Re: Minor Project Refinement No. 18 for the South Orange County Reliability Enhancement Project.

South Orange County Reliability Enhancement Project CPUC Minor Project Refinement Form

Report No.: 18

SOCRE PROJECT
MPR-18 Location 18A
San Clemente
Orange County, CA

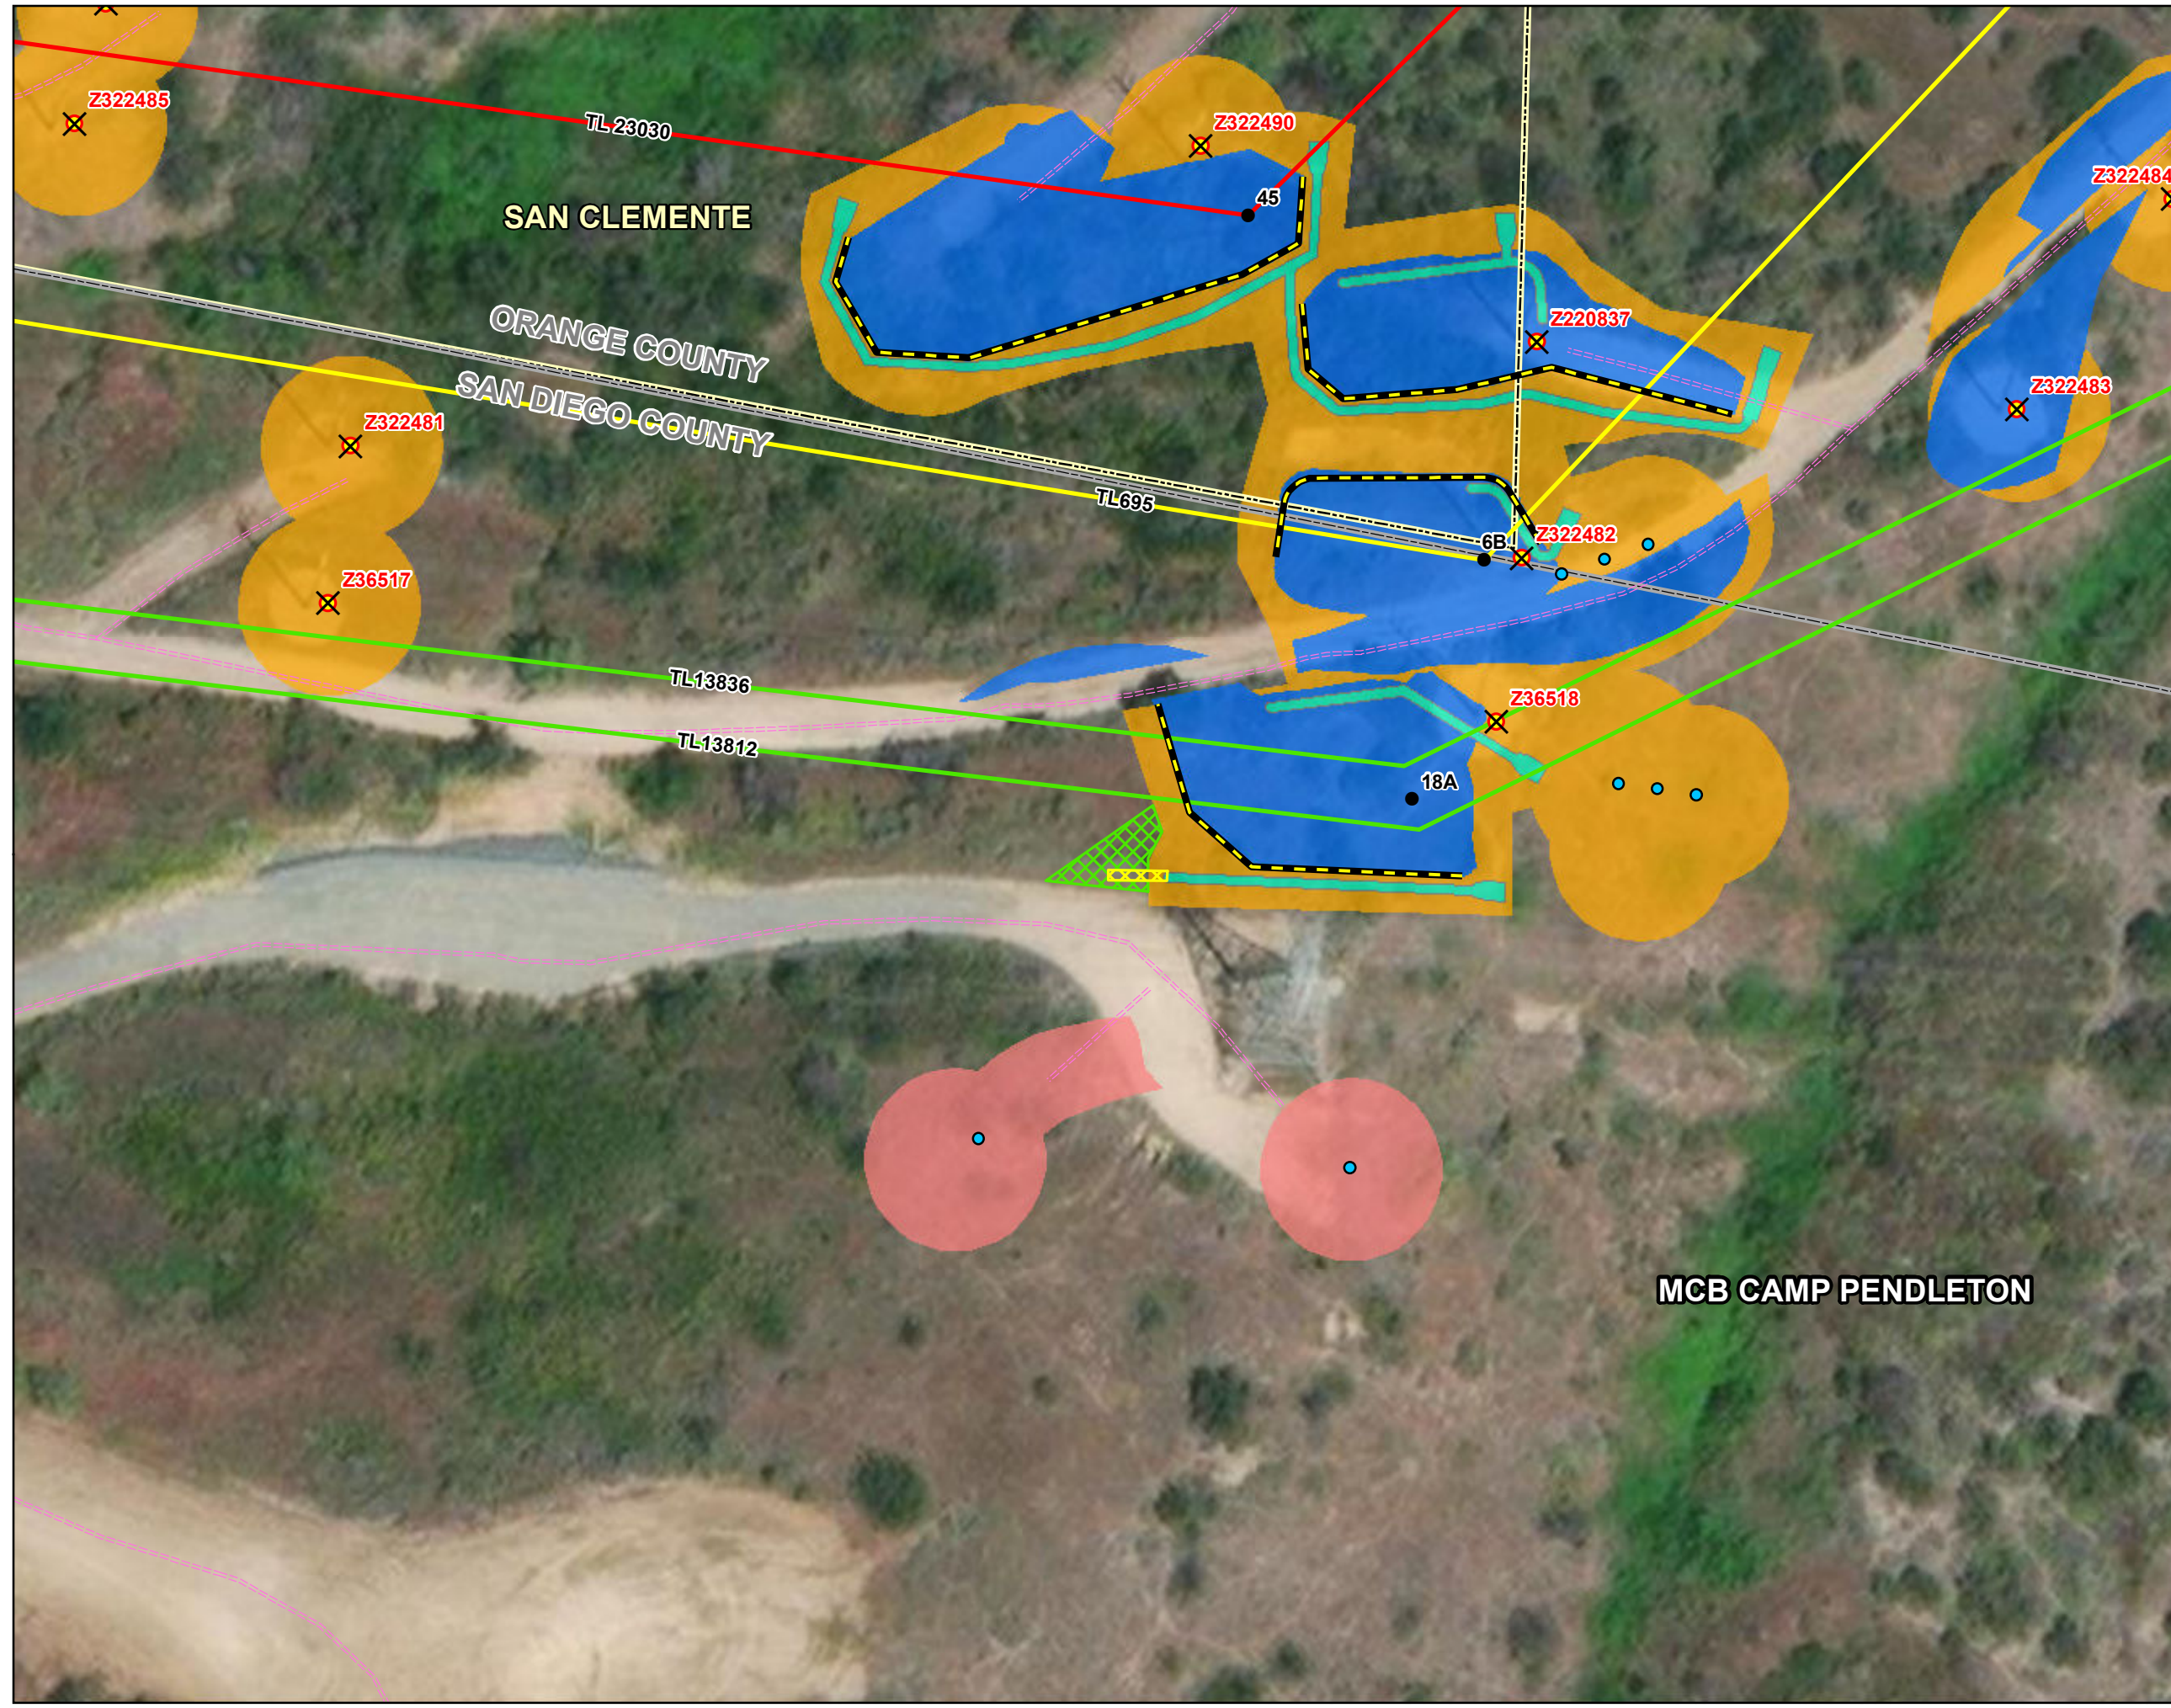
San Diego Gas and Electric (SDG&E) is requesting approval of MPR-18 for an additional work area for the South Orange County Reliability Enhancement Project (SOCRE or Project). The new work area is contiguous with the location 18A work area (previously approved in Notice to Proceed No. 7 (NTP-7)) as shown in **Attachment B, MPR-18 Figure**. The proposed MPR-18 work area will total approximately 410 square feet (0.009 acre), of which 55 sq. ft (0.001 acre) are permanent impacts for a brow ditch extension, and 355 sq. ft. (0.008 acre) are temporary impacts for the additional workspace required to construct the brow ditch.

The MPR-18 work area addition will be utilized to extend the original brow ditch design at location 18A as a form of erosion control. Excavation will take place within the 55 sq. ft. permanent impact

area to construct the brow ditch at location 18A. This 15-foot area will be excavated using hand tools or a mini excavator to a width of two feet and a depth of two feet, and then backfilled with base to form a V-ditch. The 355 sq. ft. temporary impact area will be used as additional workspace required to perform the brow ditch expansion. Trimming (mowing) will be required for disturbed vegetation within the MPR-18 work area. **Attachment B, MPR-18 Figure** shows the location of the MPR-18 work area.

The proposed work area is contiguous to a previously approved Project component, location 18A, which was approved in NTP-7 and the Amended REIR document. Two temporary work areas included in NTP-7 and the REIR (located south of the location 18A work area) will no longer be used by the Project (see **Attachment B, MPR-18 Figure**). As such, the overall temporary impact was reduced in this area as final engineering eliminated the need for those temporary poles and associated work areas (see Disturbance Acreage Changes Section below for detail).

The proposed MPR-18 work area totals 410 sq. ft. (0.009 acre), of which 55 sq. ft. (0.001 acre) is permanent disturbance for the brow ditch extension and 355 sq. ft. (0.008 acre) is temporary disturbance.

It should be noted, two temporary work areas included in NTP-7 and the REIR located south of the location 18A work area will no longer be used by the Project. These work areas total 5,800 sq. ft. (0.133 acre). As such, the total temporary disturbance in the area of 18A would still result in an overall reduction of 5,445 sq. ft. (0.125 acre) with the addition of the MPR-18 area.
